Revised P1 Panelboard 250 & 400A

Revised P1 Panelboard FAQs

New Features and Options for "Revised P1" Offering compared to the "Original P1" panels

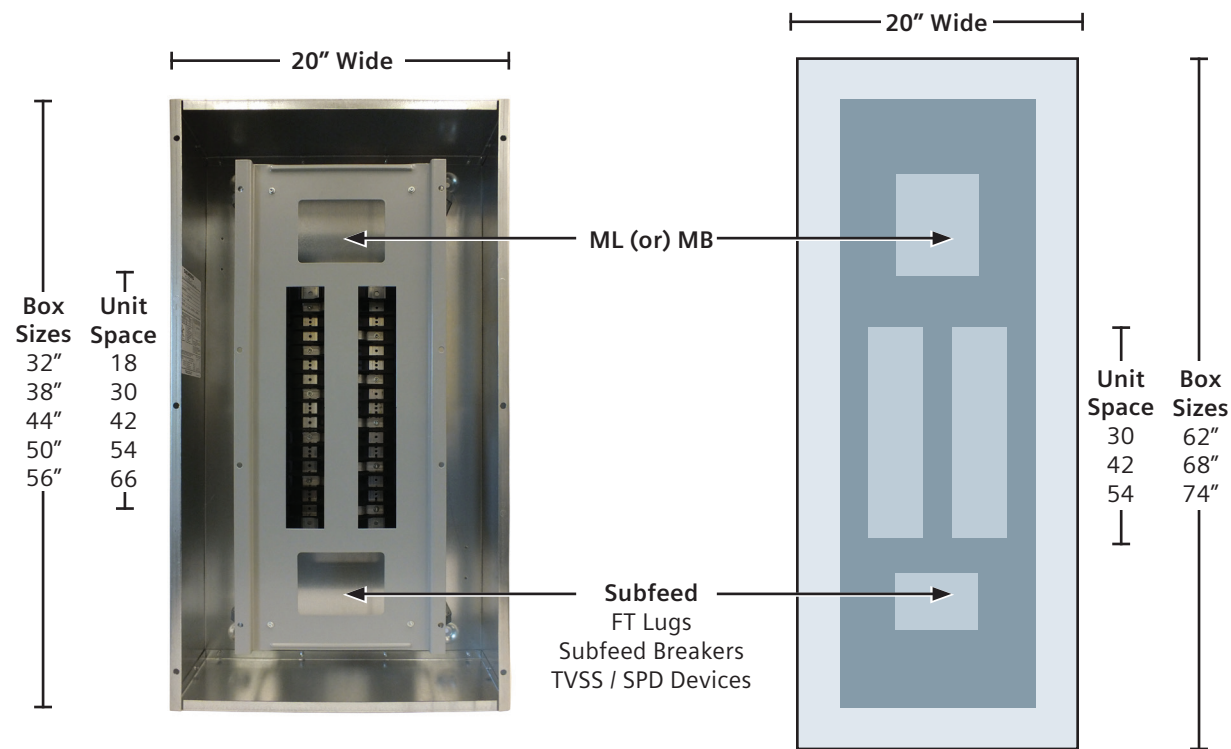
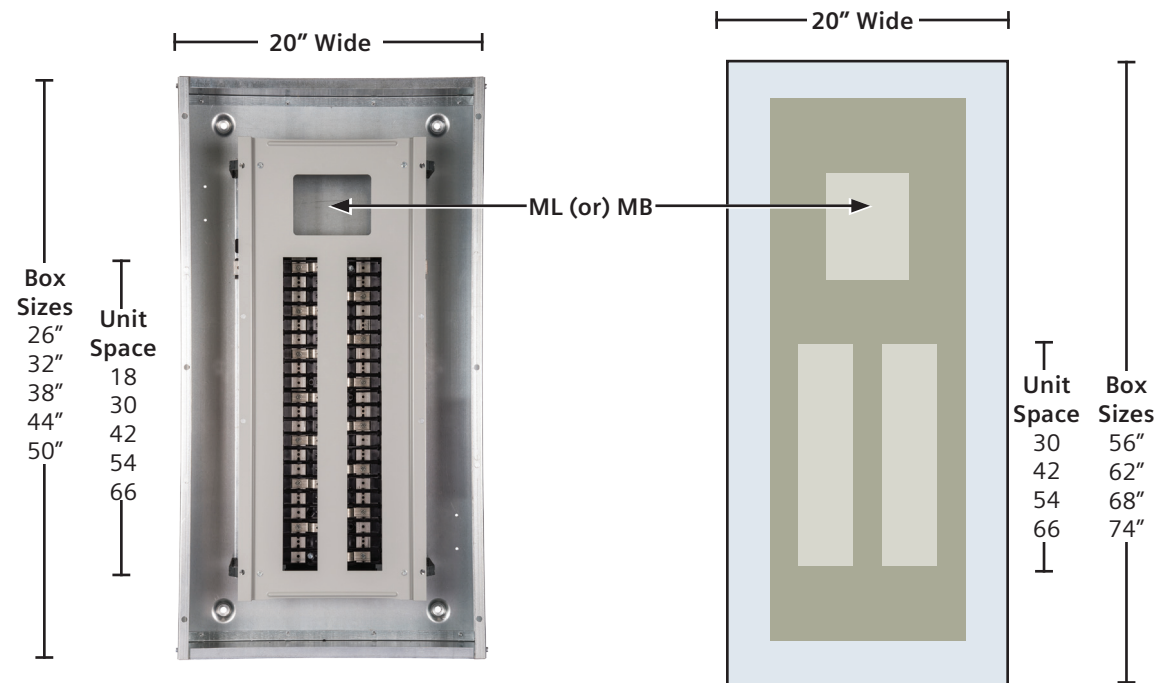
All FT and NFT are invertable in field – Top-feed or Bottom-feed

- Invertability
- Flexibility

1. Non-Feed-thru (NFT) variations of the P1 Panels are now available for Factory assembled only (not UPB):

- Feed-Through (FT) versions are versions with a Sub-feed space that can be occupied by Feed-thru lugs, Subfeed Breaker or an SPD device. All Original P1 devices were FT versions.
- Non-Feed-thru (NFT) versions do not have the Subfeed space and therefore can fit into an enclosure 6" smaller than the FT version.

- Both FT and NFT variations are fully invertable in the field and can be used for either Top-feed or Bottom-feed applications.

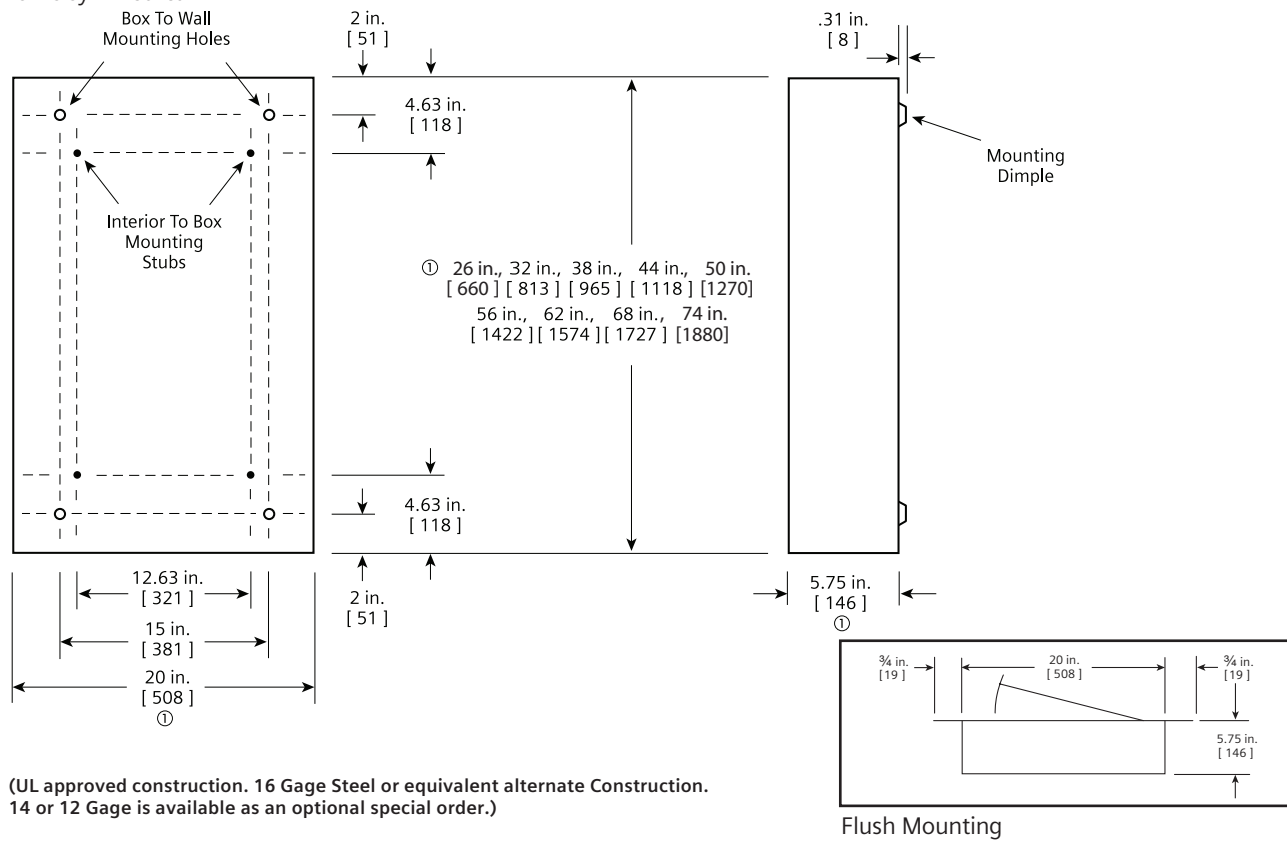
- Limits on branch breaker size for 250A 18 circuit only:

- The new Revised P1 (18 circuit 250A only) is limited to 100A per connection (200A per pair)
- Original P1 and the Revised P1 allows for the following: (except as noted above)

- 1) 100A per connection (200A per pair) for BL/BQD construction
- 2) 125A per connection (250A per pair) for xGB construction
